AFRICAN DESTINATIONS NEW OFFICE INTERIORS

RENDER DOCUMENT

Rev 1
28 10 2024

BY ACO.\RCH

241025 RENDER DRAFT 01

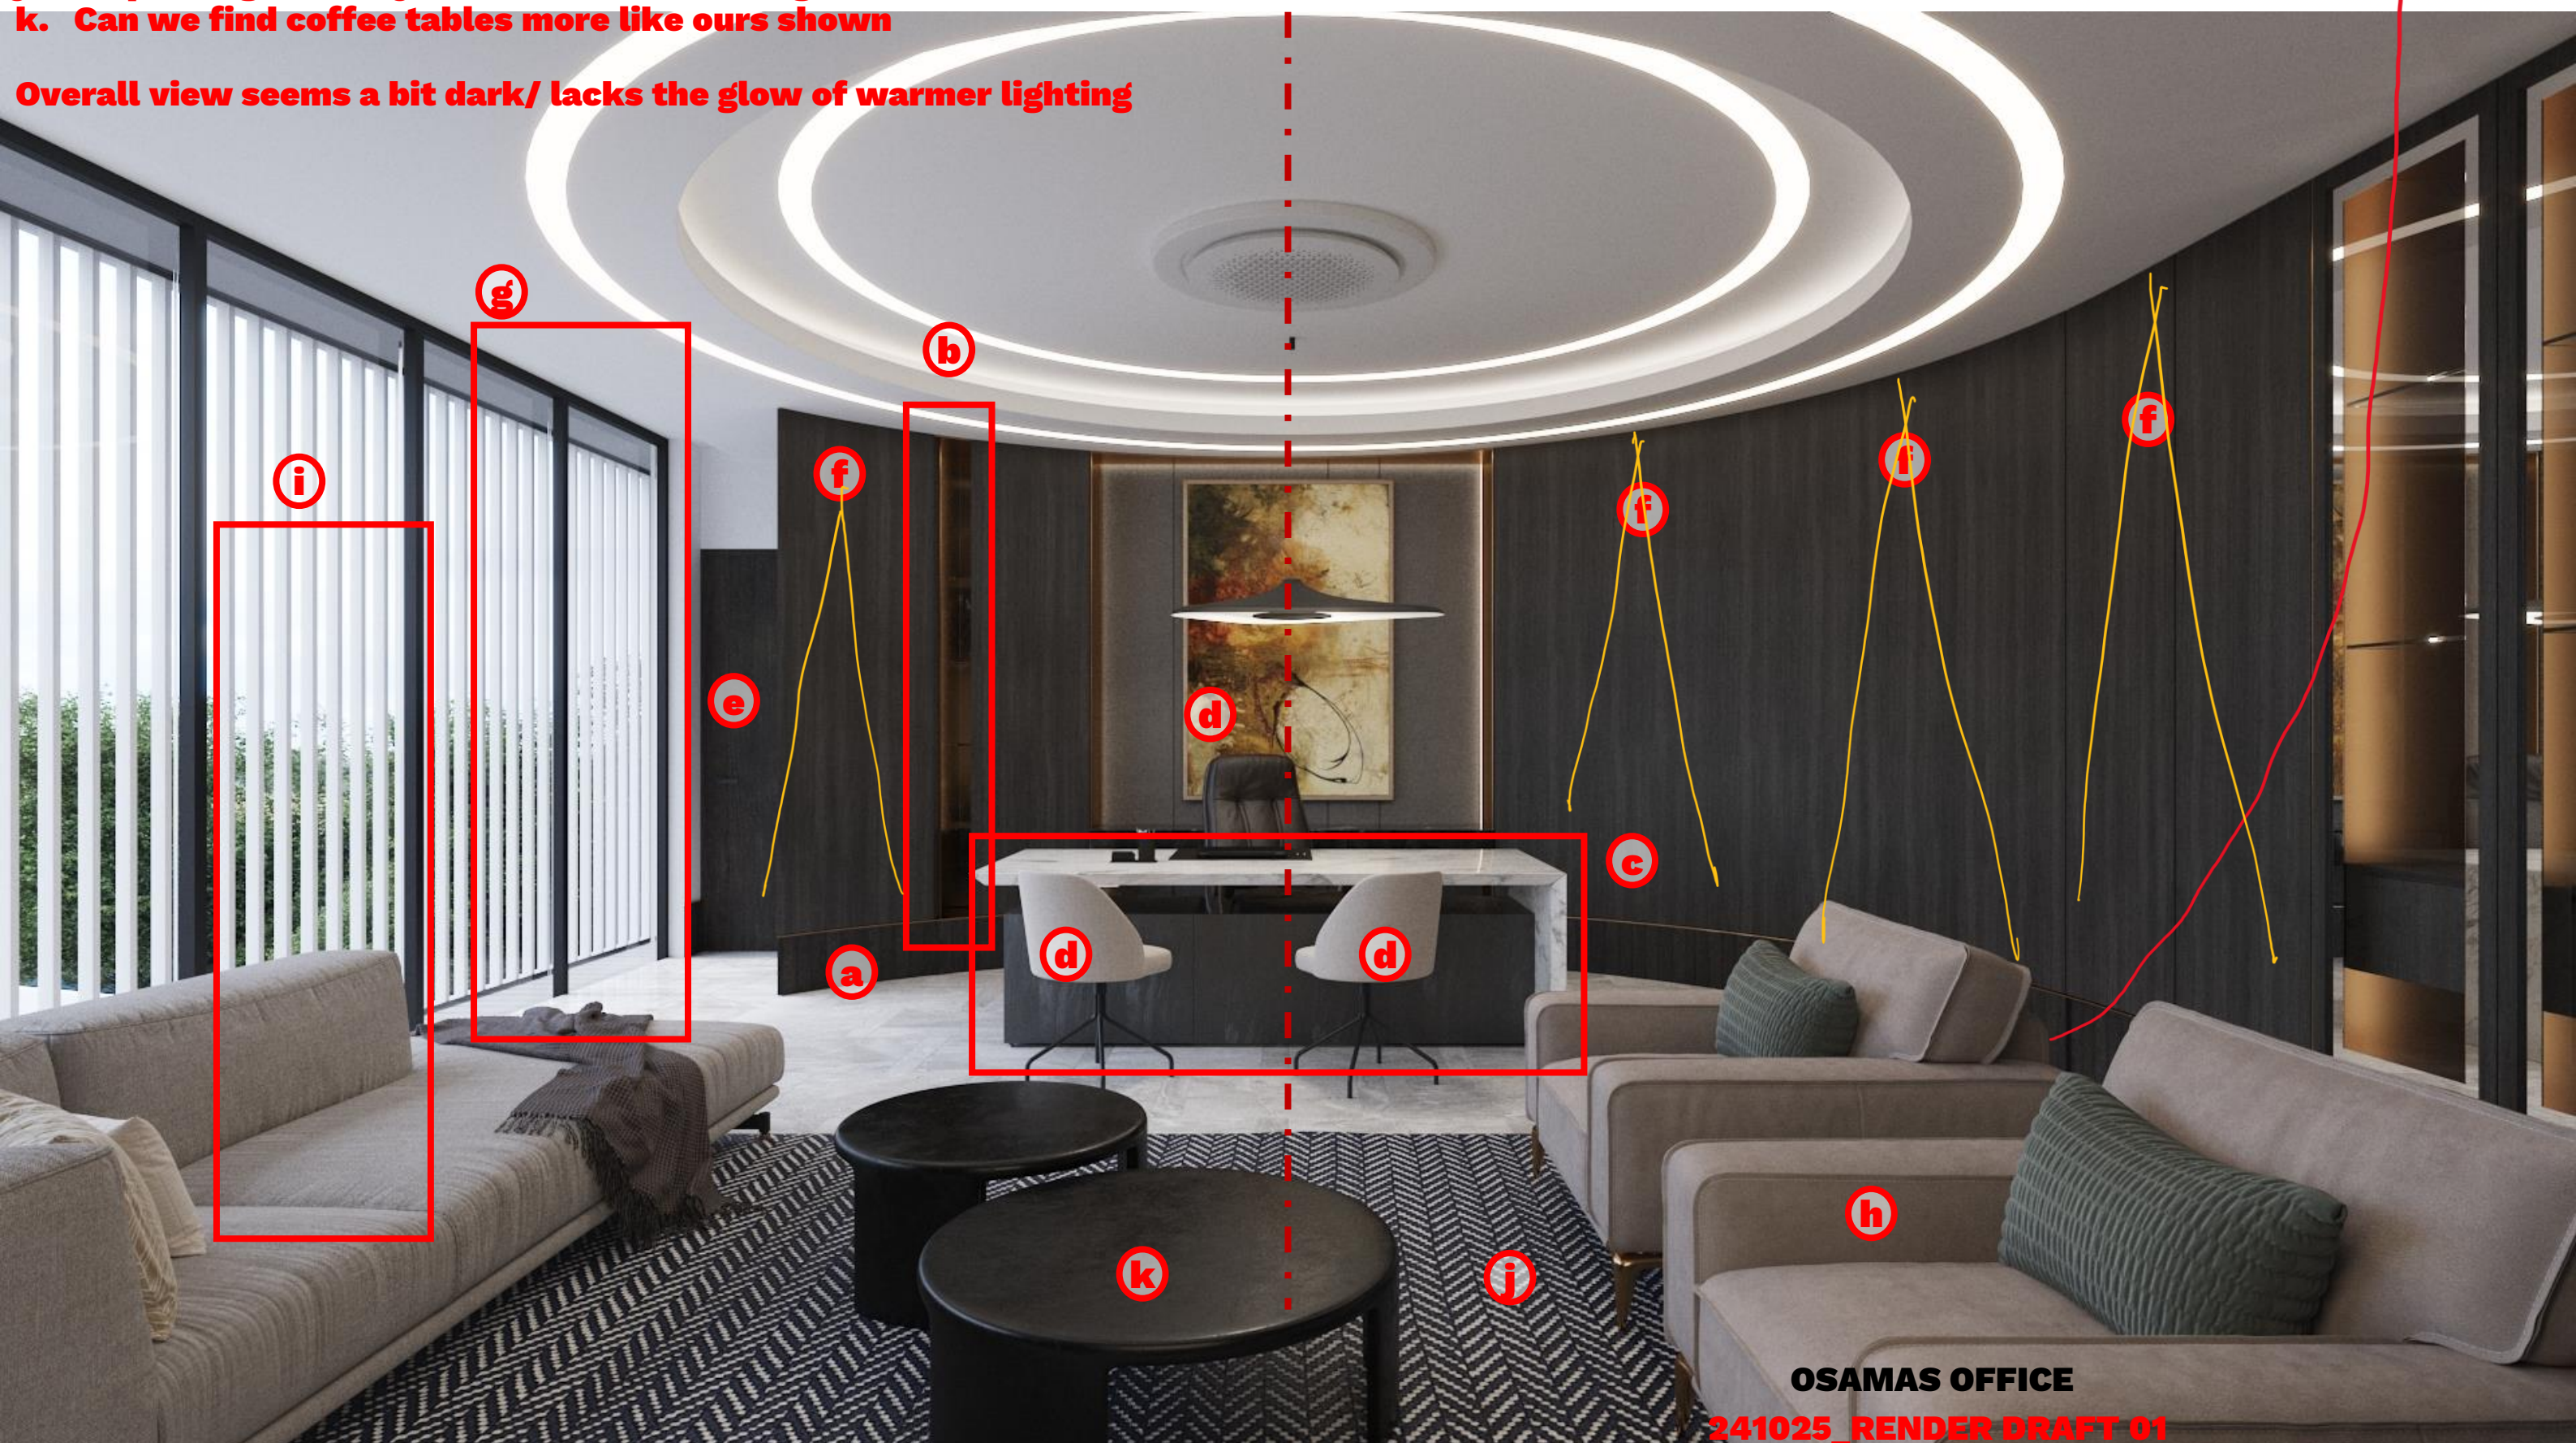
- a. Timber fluted skirting is very dark- Texture and map incorrect – see 01 on previous slide
- b. Light up shelving unit more
- c. Desk incorrect- no return to floor. Desk FBX model sent in email
- d. Center chairs and desk to room.
- e. Make Door white
- f. Add cone lights/ spot lights shining down on casework
- g. Add a curtain
- h. Less chunky arm chairs
- i. Add lamp like our view
- j. Map to rug too busy- could it be something similar to ours
- k. Can we find coffee tables more like ours shown

Overall view seems a bit dark/ lacks the glow of warmer lighting

241030 RENDER DRAFT 02

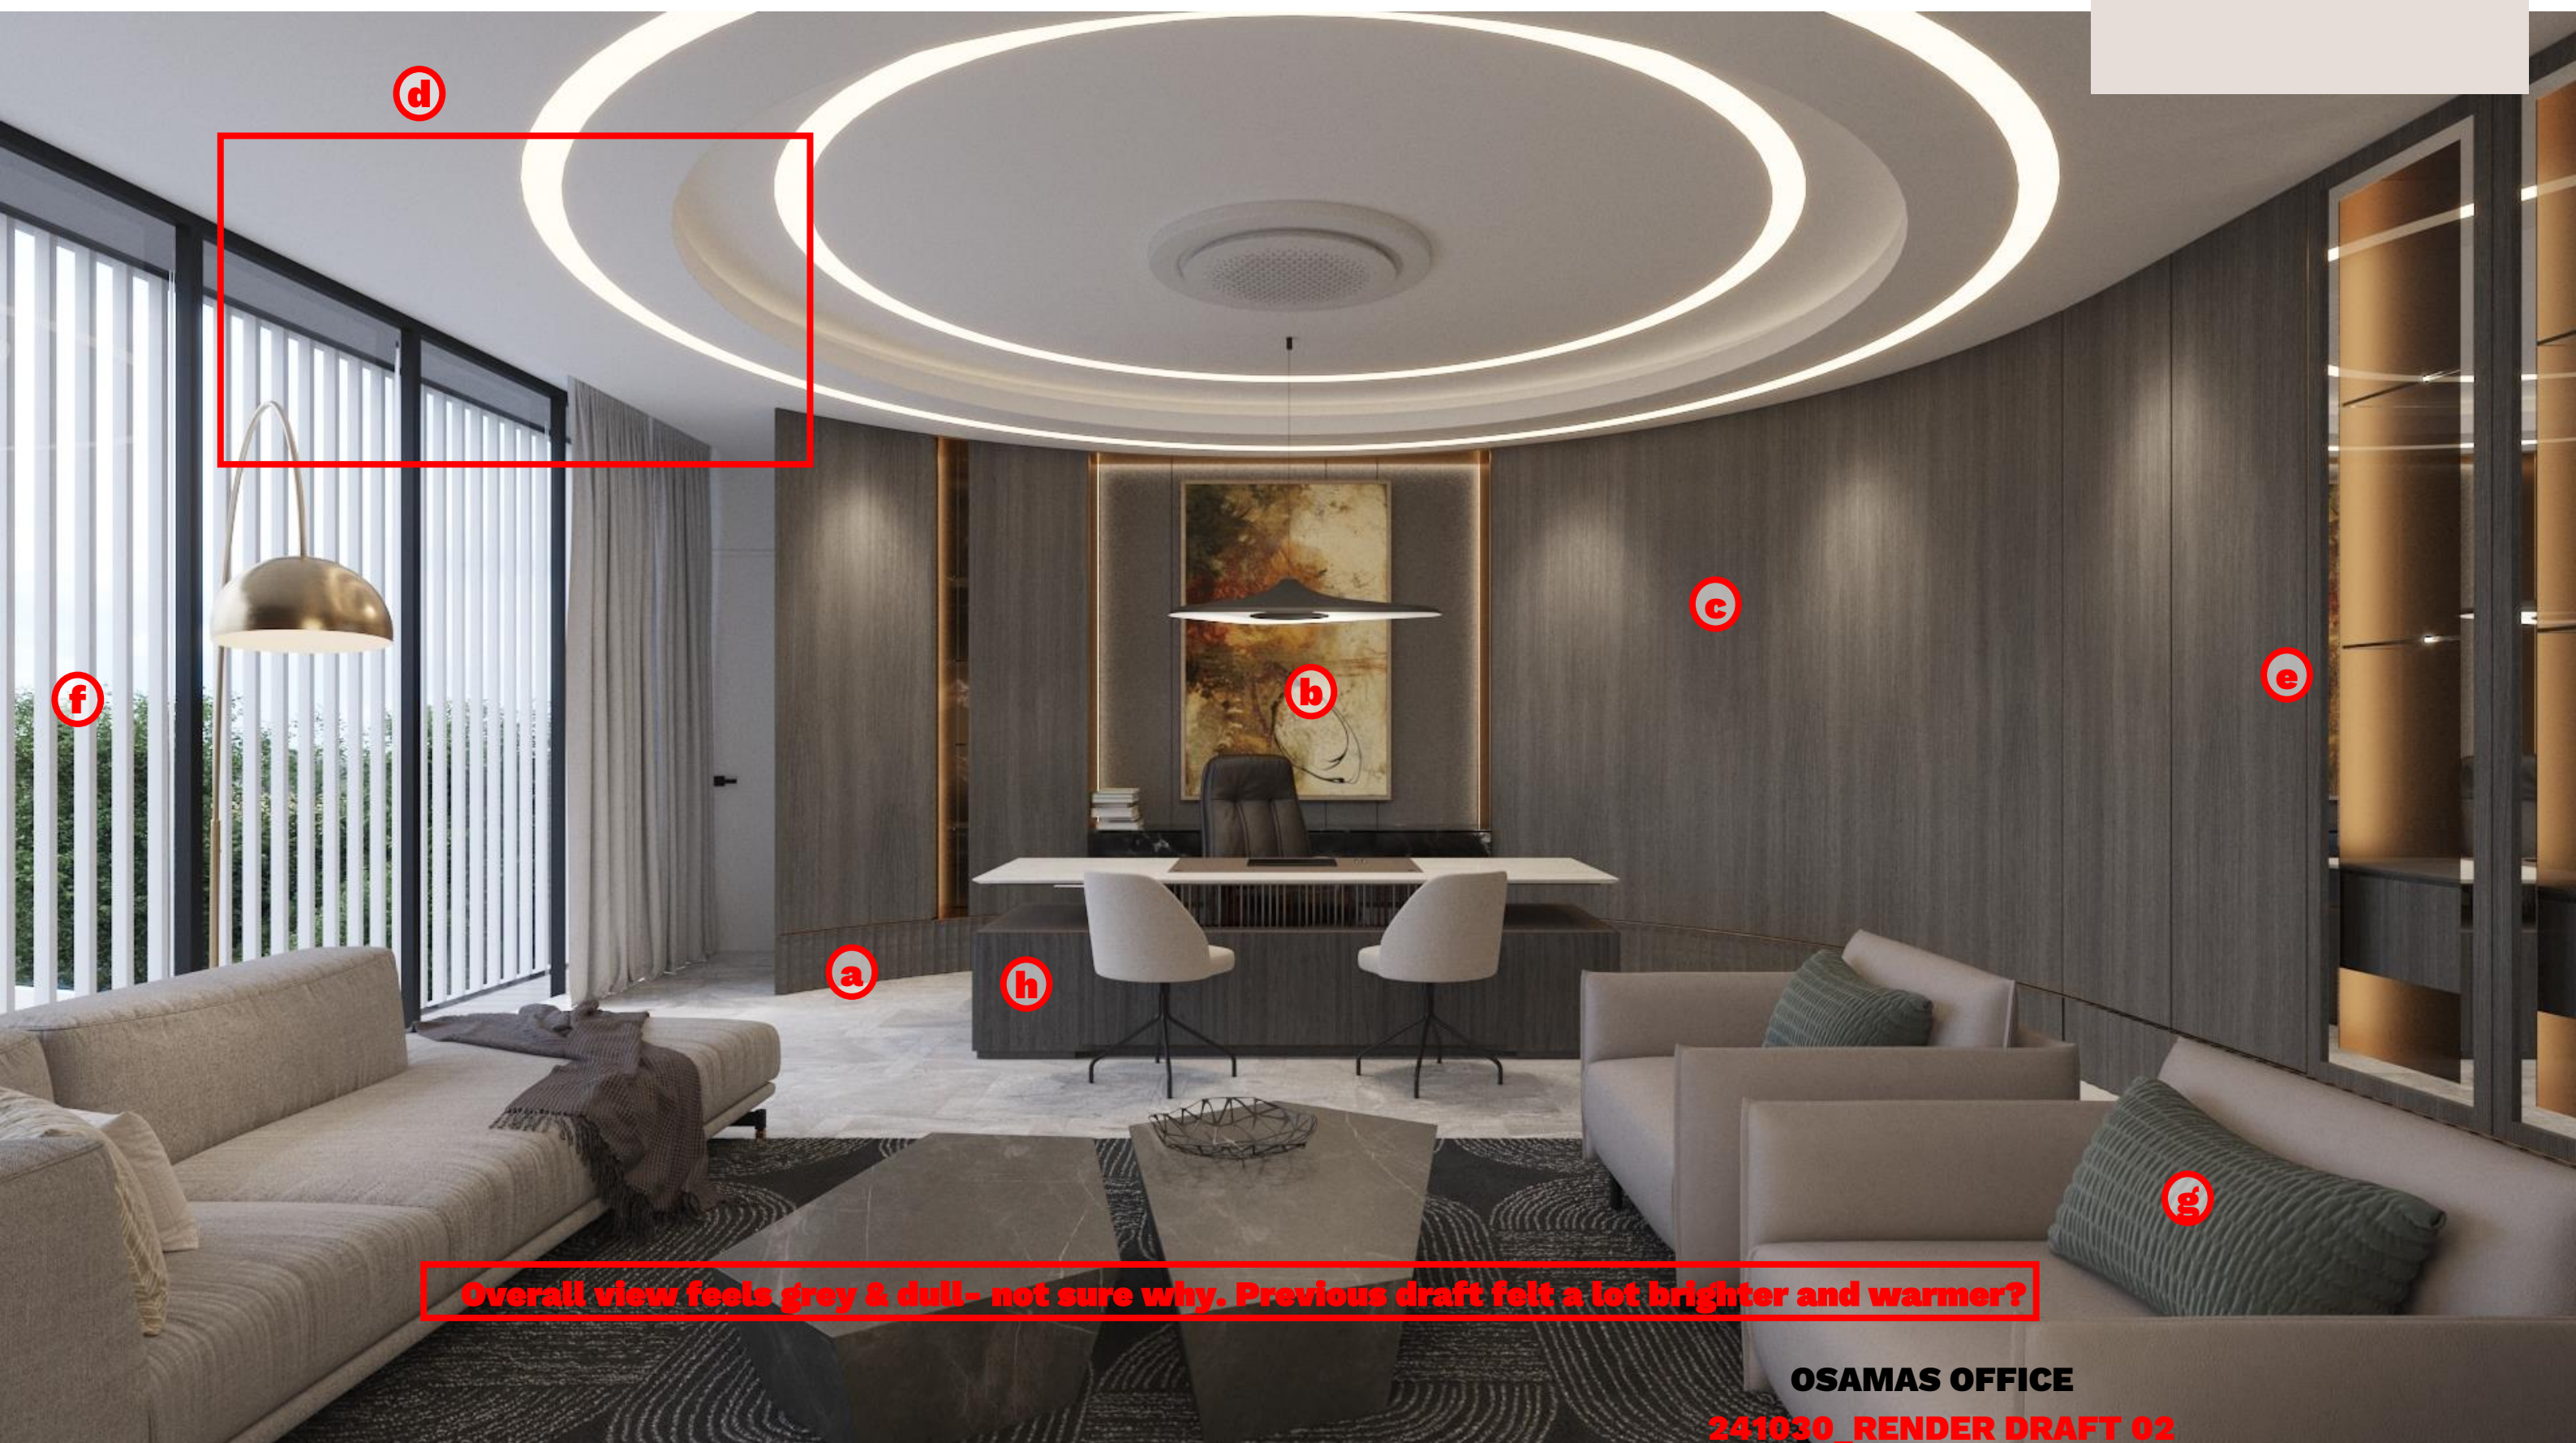
- a. Timber fluted skirting is now a little too light- scale map by 50%
- b. Artwork Map sent
- c. Updated casework and colour map sent (map not great, hope you have a better one)
- d. Track lights missing- in FBX model with Casework
- e. Glass cabinet doors to have bronze frame
- f. External screen to be dark aluminum
- g. Swap out -Match our couches- FBX sent
- h. Timber has gone a touch grey

Overall view feels grey & dull- not sure why. Previous draft felt a lot brighter and warmer?
